**STAFF RECOMMENDATION**

**1101 Halcyon Avenue**

**May 19, 2021**

**Application:** New Construction—Addition; Setback determination; Outbuilding

Figure 4 shows the area of demolition at the rear of the building.

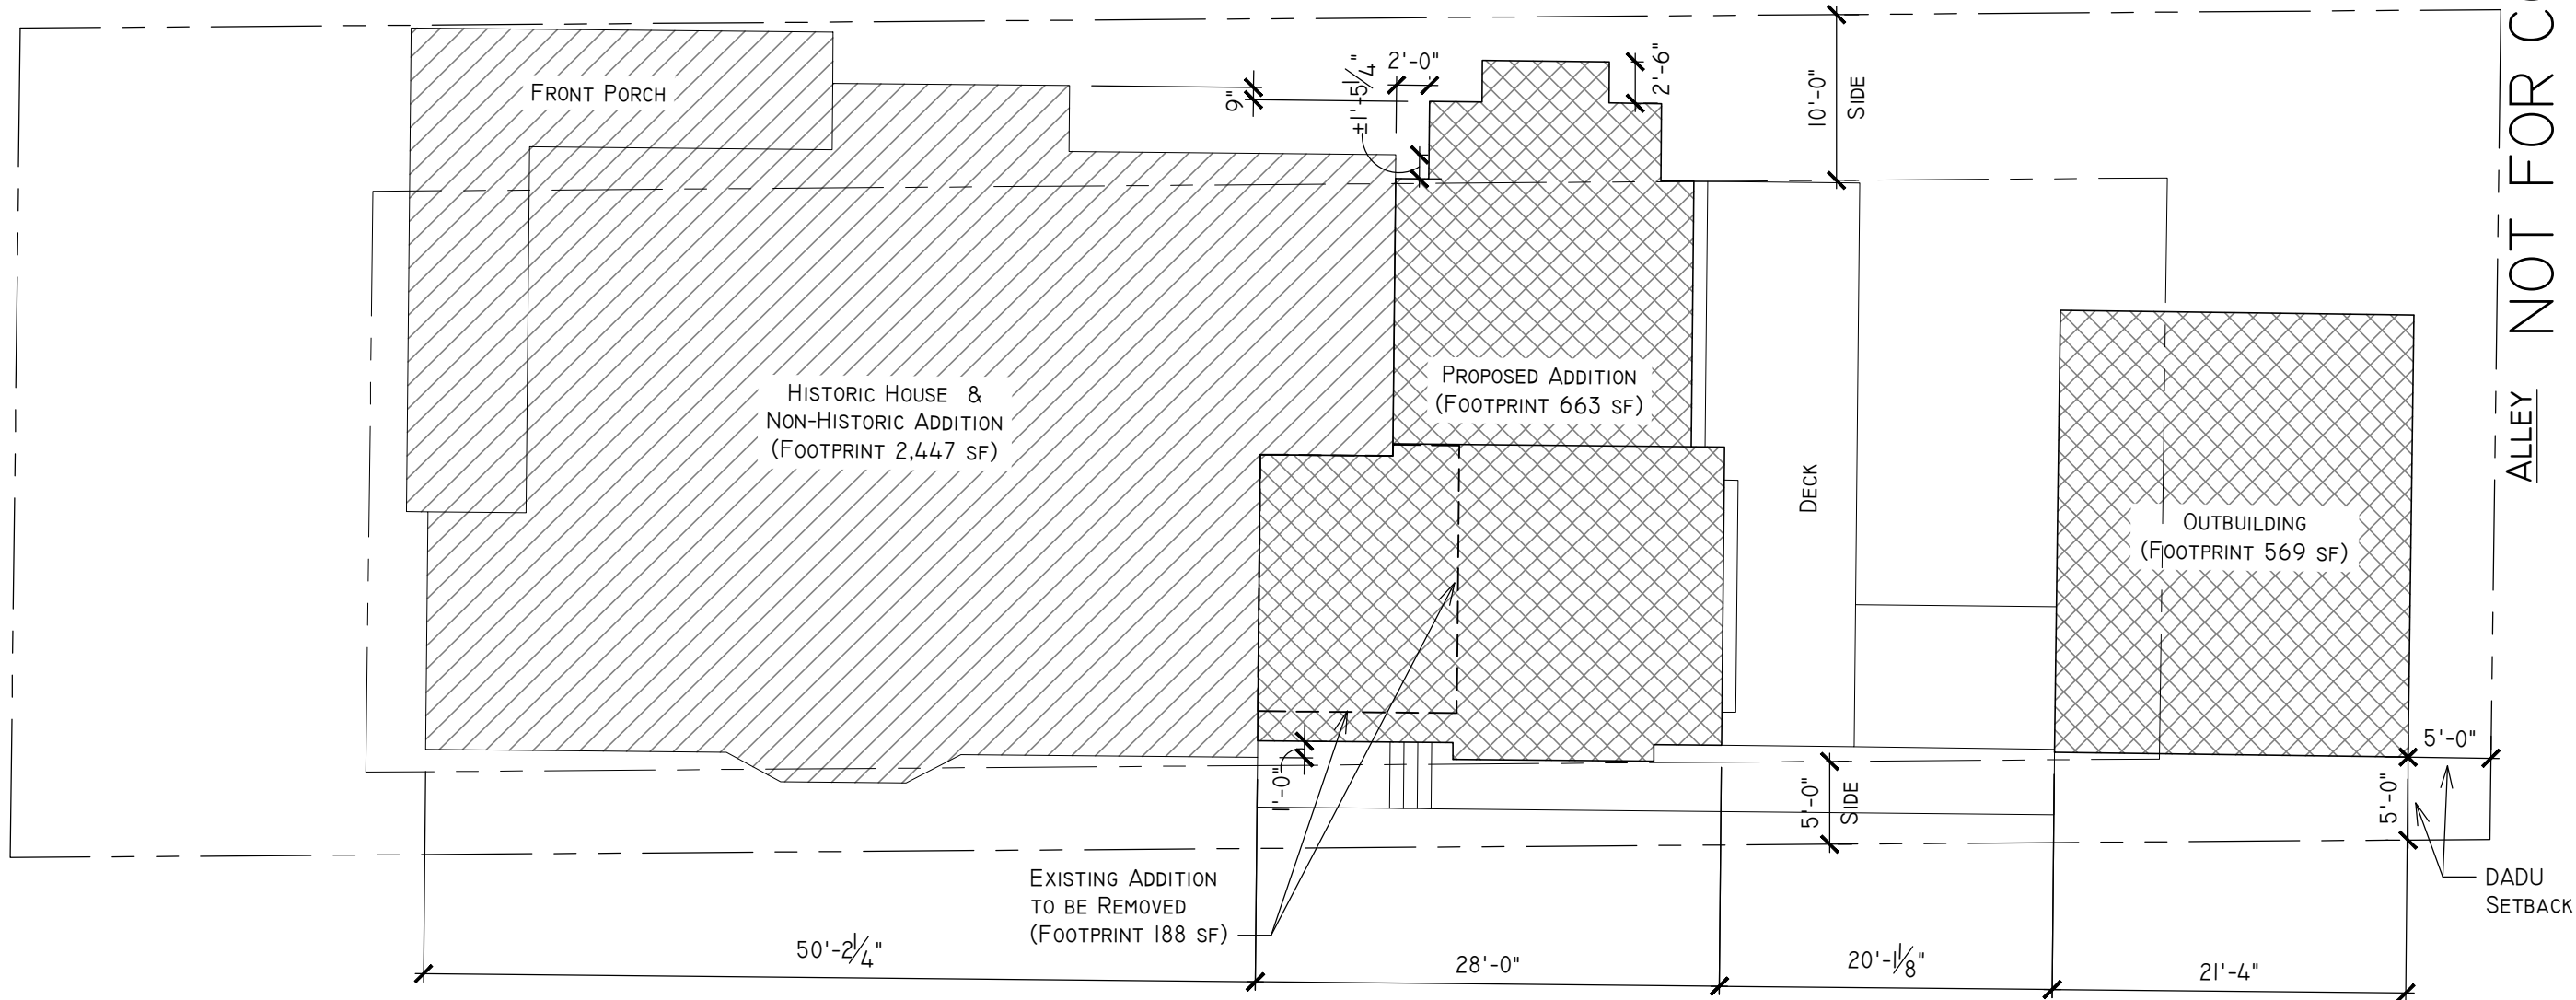
Demolition: The applicant proposes to remove an existing rear addition that was constructed after 2007 (Figure 4). This portion of the addition does not appear in the 2007 aerial (see Figure 2) and therefore its date of construction renders it non-contributing. Staff finds that this partial demolition is appropriate demolition under the design guidelines.

Staff finds that the removal of the rear extension is appropriate demolition, meeting Section V.B.2. of the design guidelines.

SITE PLAN  
 01

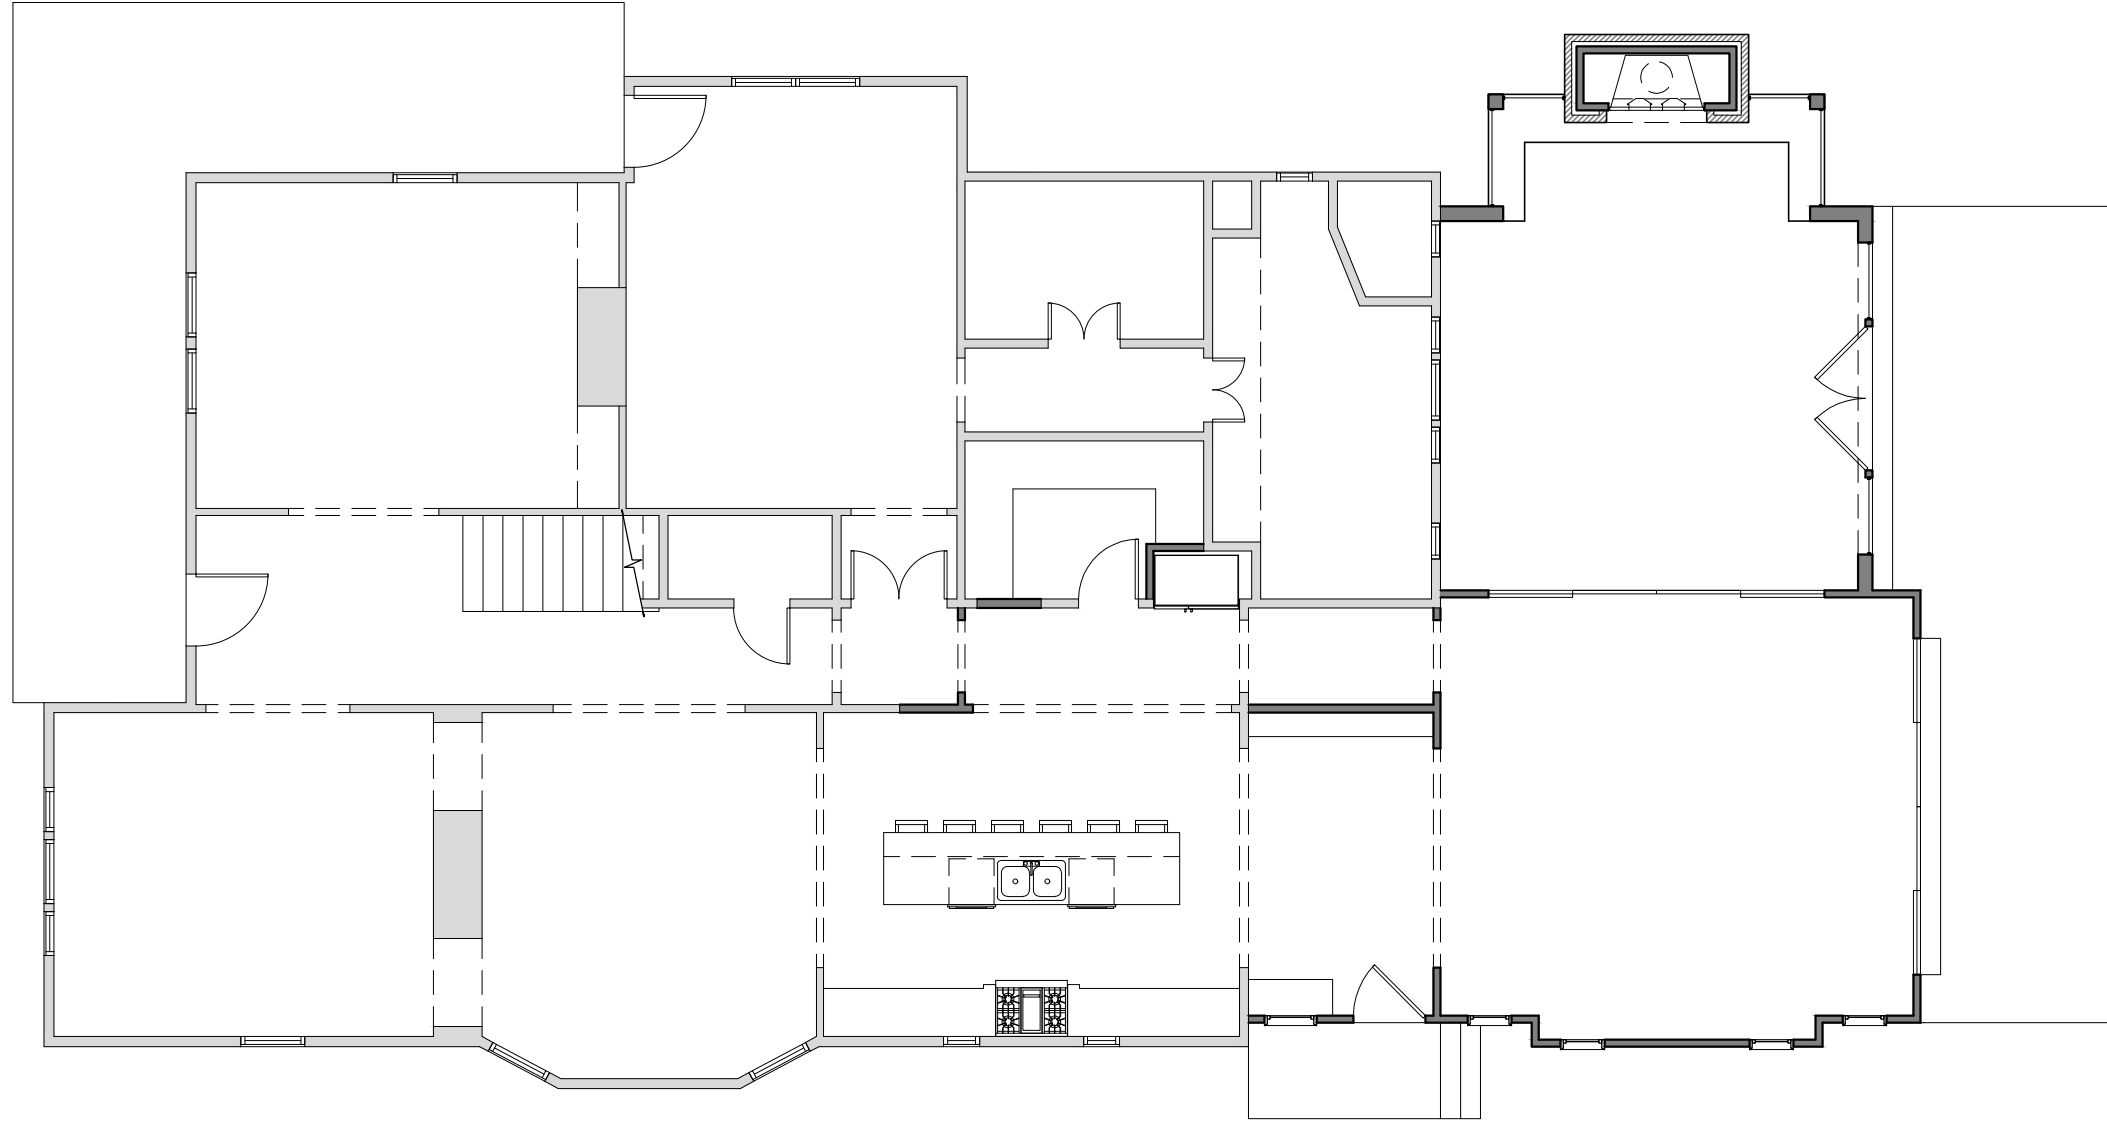
Setback & Rhythm of Spacing: The addition does not meet the base zoning setbacks on the 11<sup>th</sup> Avenue South property line. There is a required ten-foot (10') side setback from the 11<sup>th</sup> Avenue South side property line. The application proposes a setback of as little as two feet, eight inches (2'8") from the 11<sup>th</sup> Avenue South property line, although that is for the brick ventless chimney. The wall of the addition will be approximately five feet, four inches (5'4") from the side property line. Staff finds this proposed side setback to meet the design guidelines because the historic house does not meet the side setbacks on either façade. The addition will not be any wider than the historic house and will, in fact, be largely be narrower than the historic house, not counting the ventless chimney which is typically treated as an allowable setback intrusion. In addition, the addition's depth is not overly large with a maximum depth of twenty-eight feet (28'). The depth of the area the intrudes into the side setback is just about fourteen feet (14').

The addition is five feet (5') from the right side property line, which meets the design guidelines. The addition will be approximately forty-six feet (46') from the rear property line, which meets the base zoning setback, and there will be at least twenty feet (20') of space between the back of the addition and the planned outbuilding.

Staff finds that the proposed setbacks and rhythm of spacing to meet Sections III.C. and IV. of the design guidelines.
